Model	F200 Finisher	Volt/Hz	Date of Modification	Serial Number
Modified Article	Parts Catalog			
Reason for Modification	Parts Catalog Correction

DETAILS OF MODIFICATION

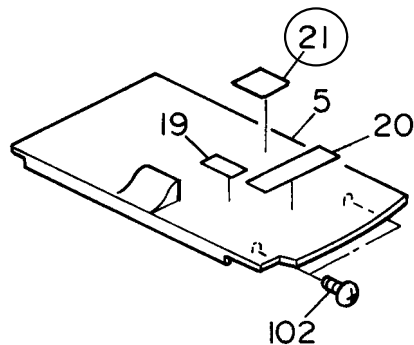
2. illustration correction

Please add the following illustration to your parts catalog:

Page 4 Index 21

Page 30 Index 11

During machine operation, to reduce the risk of injury avoid touching moving parts at the finisher exit section.

Open the finisher front door to de-energize the moving parts.

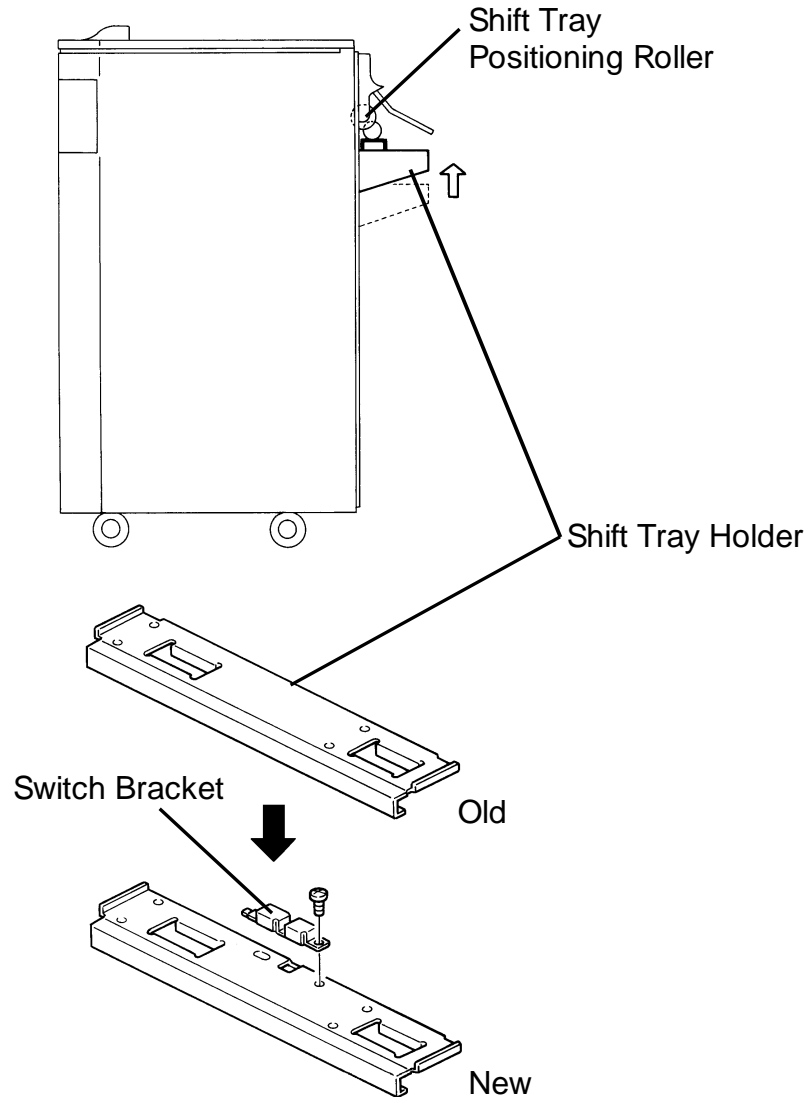
The shift tray positioning roller cannot be pushed up by the shift tray if it is removed while servicing. If the main switch is turned on under this condition, the shift tray motor starts rotating but it does not stop. Then, the shift tray holder continues to be lifted up. This may cause the driving parts to be damaged.

1. The switch bracket has been installed on the shift tray holder so that the switch bracket pushes up the shift tray positioning roller even if the shift tray is removed.
2. Holes for installing the switch bracket have been made on the shift tray holder. However, its part number remains the same.

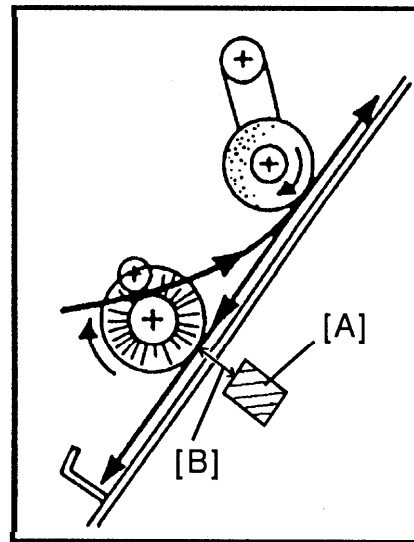
When a heavy curled copy paper reaches the jogger unit of the finisher, the jogger unit paper sensor [A] may not detect it because of the large distance [B] between the paper and sensor. To prevent this, the photosensor has been changed to a long range sensor.

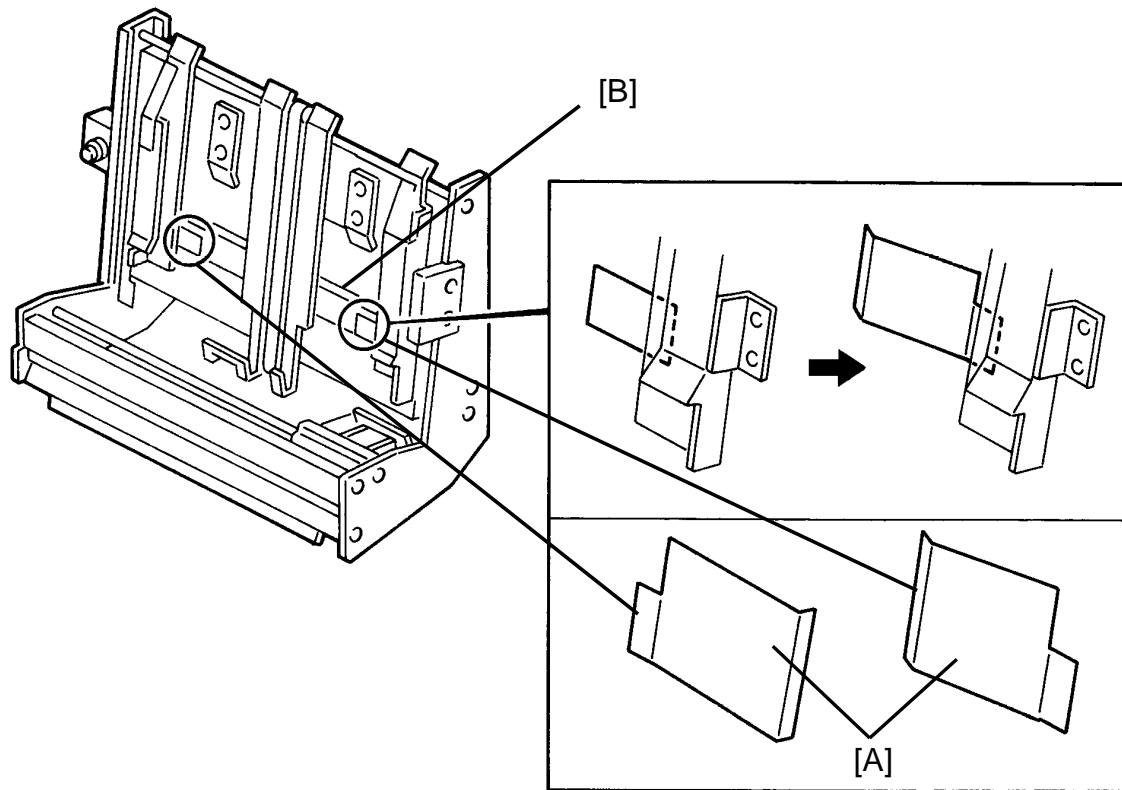
To ensure paper transportation in the jogger unit, the slider seals have been enlarged. The new slider seals [A] cover the guide rod [B] to prevent paper from contacting the guide rod and causing a paper jam.

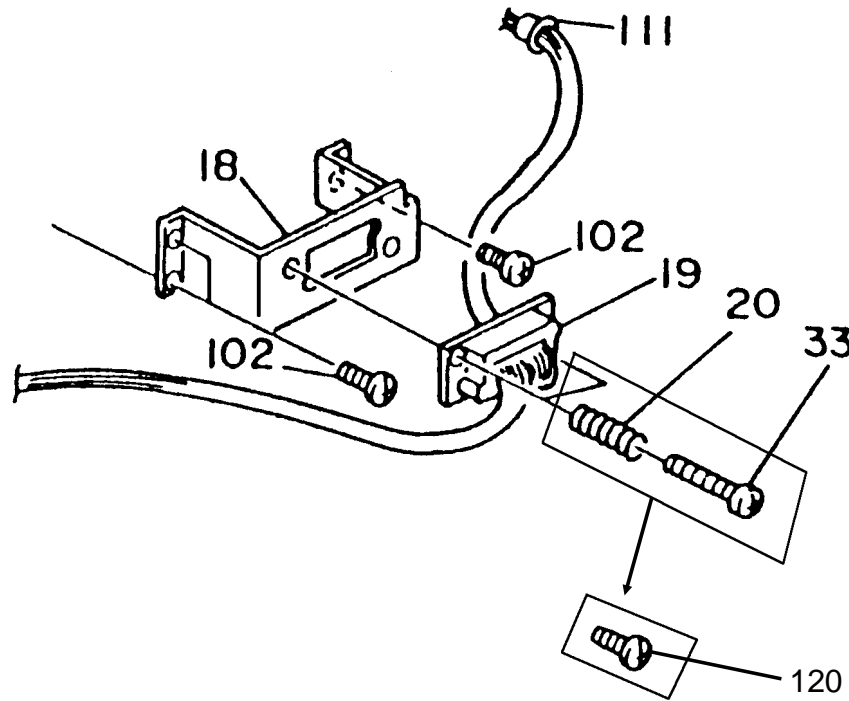
To allow easier positioning of the main harness connector to the stapler connector in the factory, the spring connector (AA063068, index 20) and the connector guide pin (54465832, index 33) have changed to M3 x 8 screws. Before this modification, the position of the connector had to be adjusted to the joint connector bracket (A3531157, index 18) by adjusting the 4 screws. Now the position of the connectors can be adjusted using only the 2 screws (index 120), as per the modification. This is to allow easier positioning of the connectors.

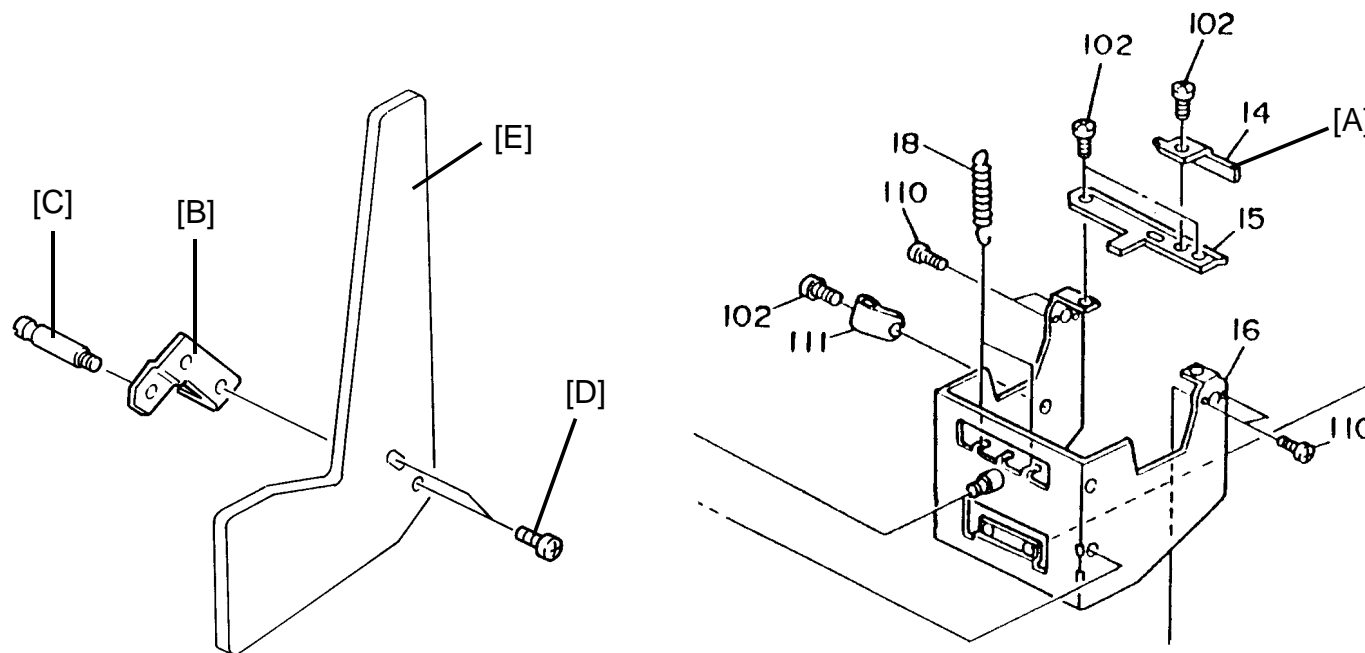
When a customer replaces the staple cartridge, if he forces the stapler unit to rotate after it contacts the stapler rotation bracket (A3532854) [A] the bracket will be bent and the unit will come off the guide rod. To prevent this, the stapler unit stopper (A3532855) [B] and the pin (54031910) [C] have been added so that the stapler unit stops rotating when it contacts the pin [C]. Two holes have been added to the staple unit side plate to install the stapler unit stopper with two screws [D]. The part number of the modified staple unit side plate (A3532601) [E] has been registered . The stapler rotation bracket [A] has been removed.

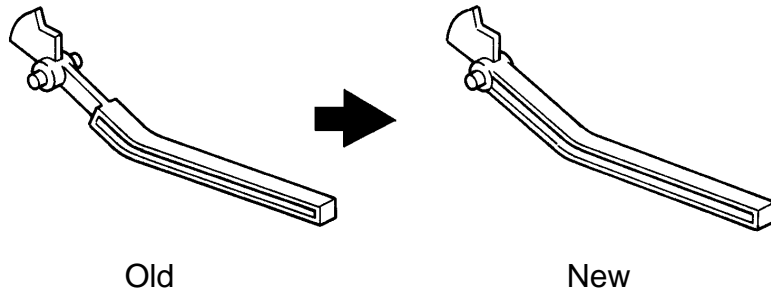
Due to part standardization with the finisher for F410/420, the following part has been changed.

P/N	New P/N	Description	Q'ty Used	Inter-change-ability	Parts Catalog	
					Index No.	Page
A3533171	Z A3791225	Actuator Bracket	1 → 0	O/O	19	17
		Upper Sensor Actuator	0 → 1

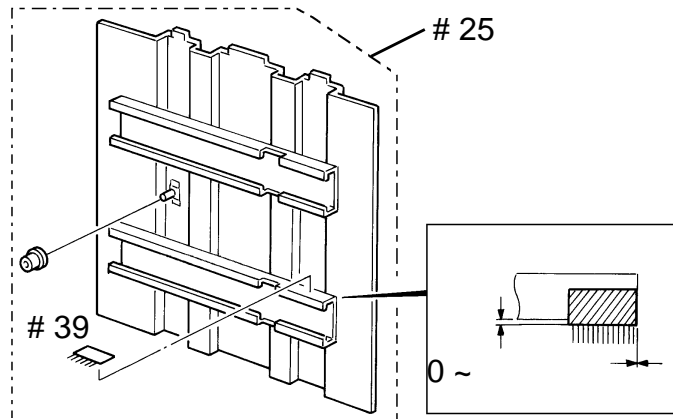
To prevent static electricity, an antistatic brush has been added to the end fence.

NOTE: When sticking the antistatic brush on the old end fence, the paint on its seat should be removed to ensure the grounding of the brush.

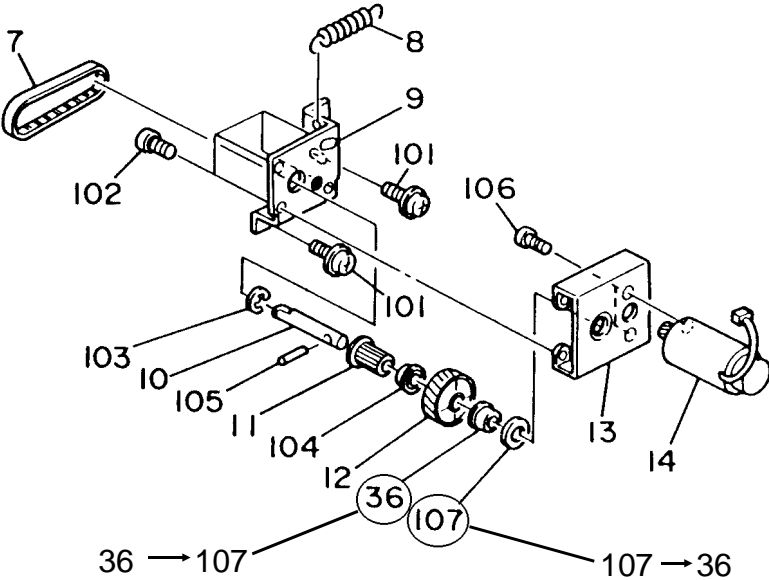
* Index number correction in illustration
Page 16 Index No. 36 → 107
 107 → 36

Page 12 : Transport Unit

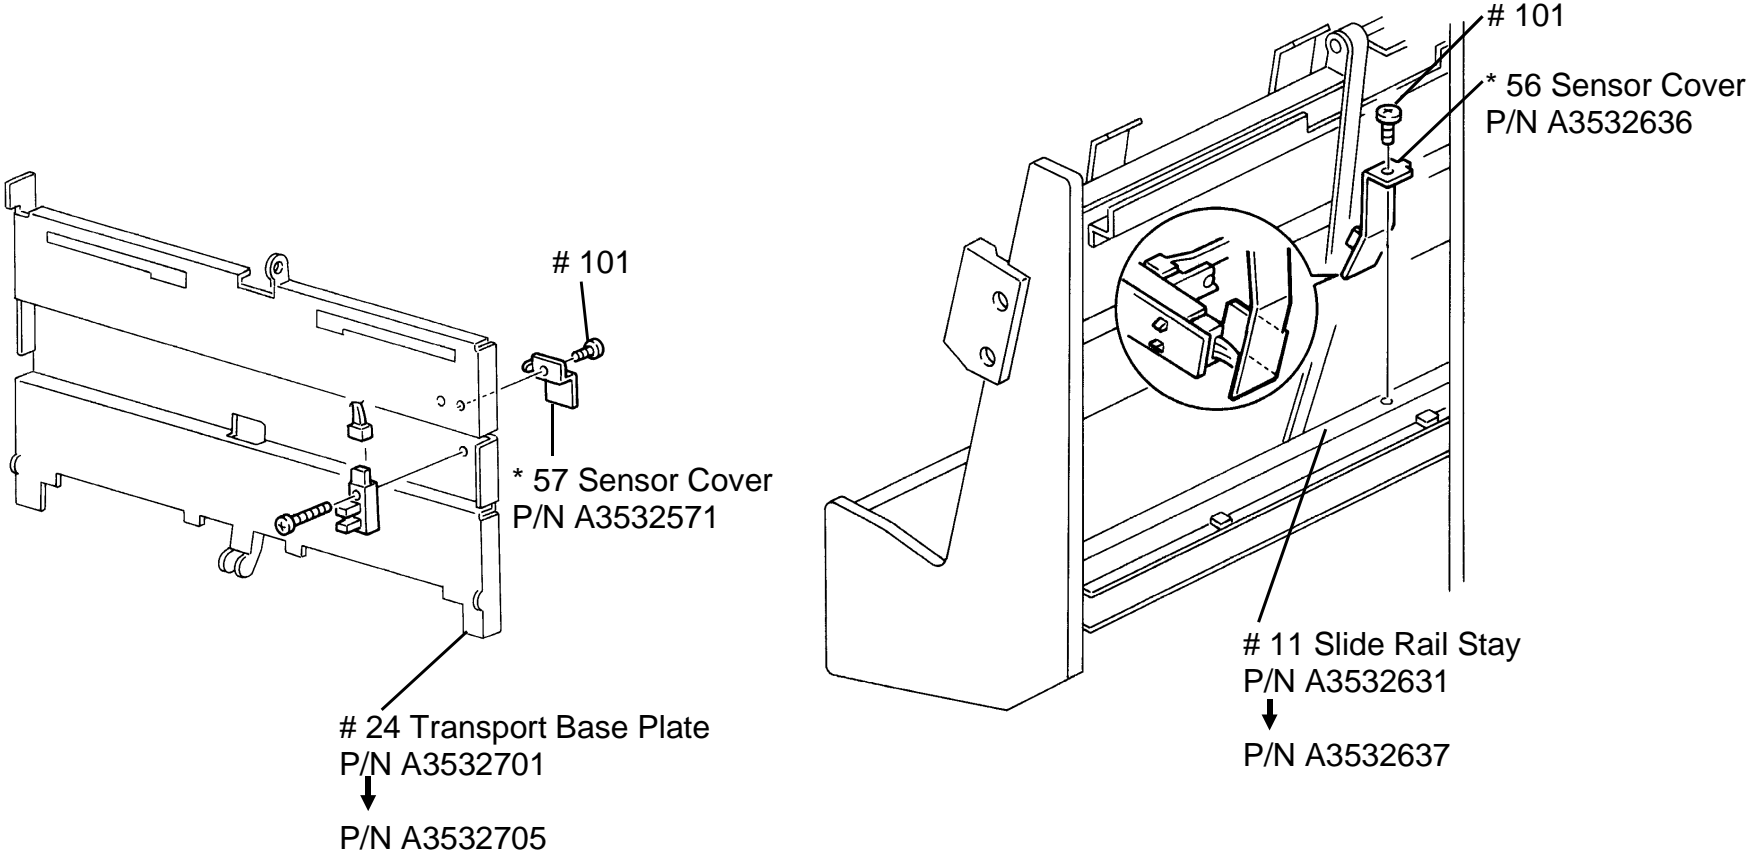
To meet the Conformité Européenne (CE) standards, the sensor covers have been added as shown.
